Project	<b>IEEE 802.20 Working Group on Mobile Broadband Wireless Access</b> <b><a href="http://grouper.ieee.org/groups/802/20">http://grouper.ieee.org/groups/802/20</a></b>	
Title	<b>Requirements: Selected topics, including MAC+PHY aggregate capacity</b>	
Date Submitted	<b>2003-05-05</b>	
Source(s)	Marianna Goldhammer Tel Aviv, HaBarzel 21  Israel	Voice: +972 3 645 6241 Fax: Email: <a href="mailto:marianna.goldhammer@alvarion.com">marianna.goldhammer@alvarion.com</a>
Re:	MBWA Call for Contributions 802.20-03/09	
Abstract		
Purpose	The scope of this contribution is to improve the 802.20 Requirement document, Ver. 3.	
Notice	This document has been prepared to assist the IEEE 802.20 Working Group. It is offered as a basis for discussion and is not binding on the contributing individual(s) or organization(s). The material in this document is subject to change in form and content after further study. The contributor(s) reserve(s) the right to add, amend or withdraw material contained herein.

## **Requirements: Selected topics, including MAC+PHY aggregate capacity**

*Marianna Goldhammer, Alvarion*

The scope of this contribution is to improve the 802.20 Requirement document, Ver. 3.

**Figure 1—802.20 protocol layering, showing service access points (SAPs)**

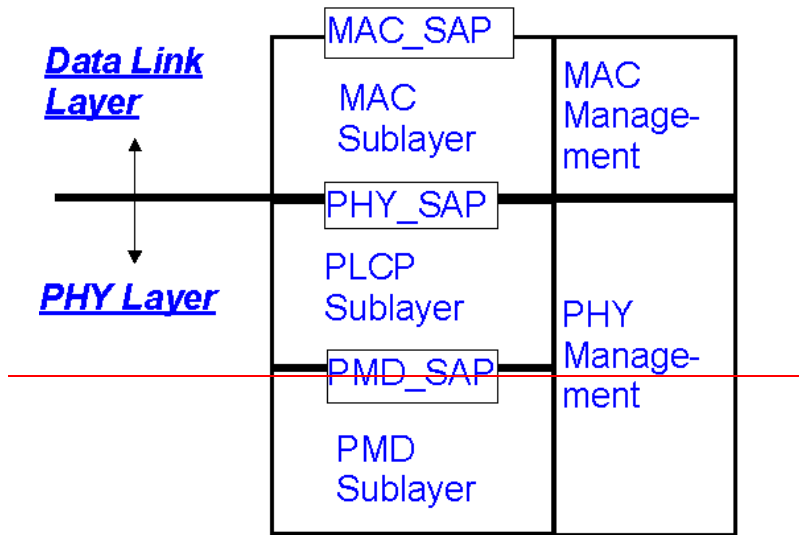
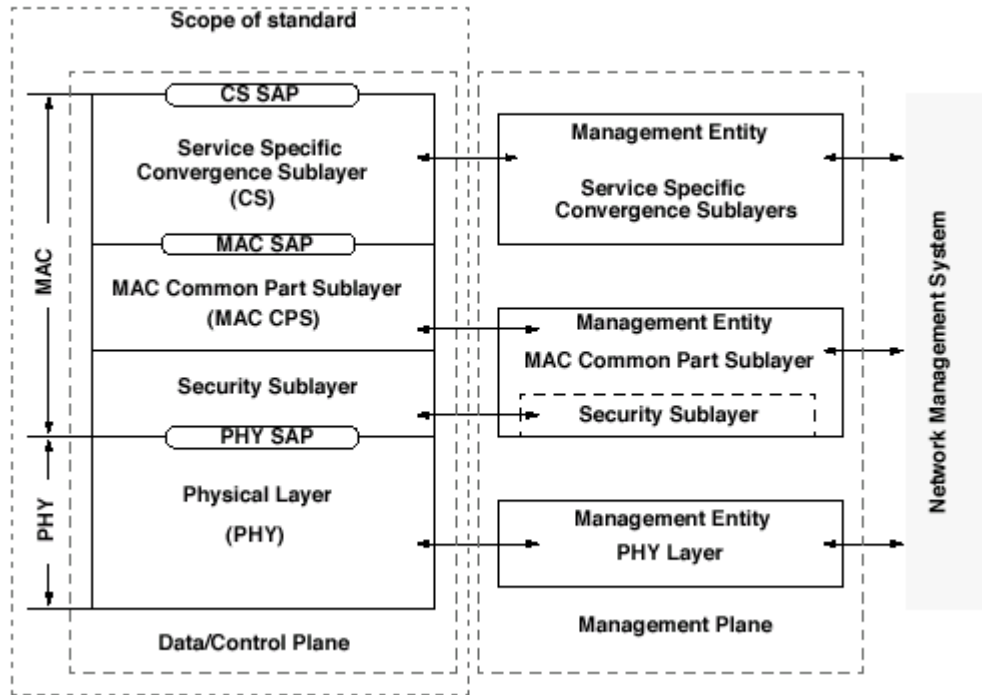
25 To aid the discussion in this document and in the 802.20 specifications, a straw man  
26 Reference Partitioning of the 802.20 functionality is shown in Figure 1. This reference  
27 partitioning model is similar to those used in other 802 groups.

28 The 802.20 reference model consists of two major functional layers, the Data Link Layer  
29 (DLL) and the Physical Layer (PHY).
